RE: OCONEE NUCLEAR STATION, UNIT NOS. 1, 2 & 3

SAFETY EVALUATION BY THE OFFICE OF NUCLEAR REACTOR REGULATION

SUPPORTING AMENDMENT NO. TO LICENSE NO. DPR-38

OCONEE NUCLEAR STATION, UNITS NO. 1, 2 AND 3

TABLE 6.1-1

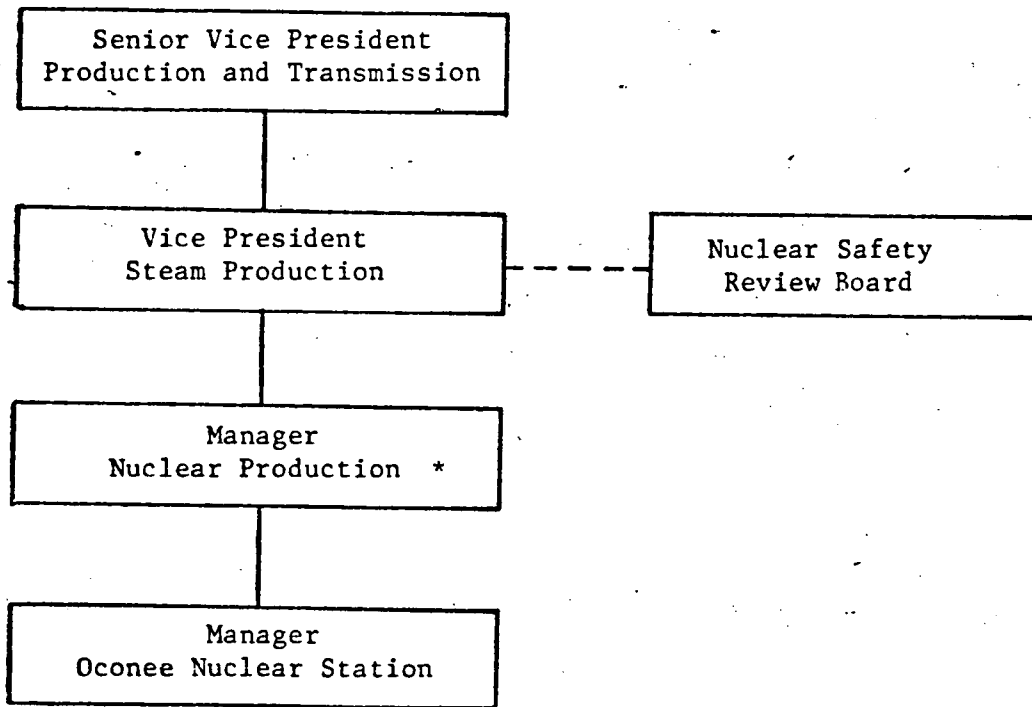
7. A fire brigade of 5 members shall be maintained on site at all times. This excludes 3 members of the minimum operating shift requirements that are required to be present in the control rooms.
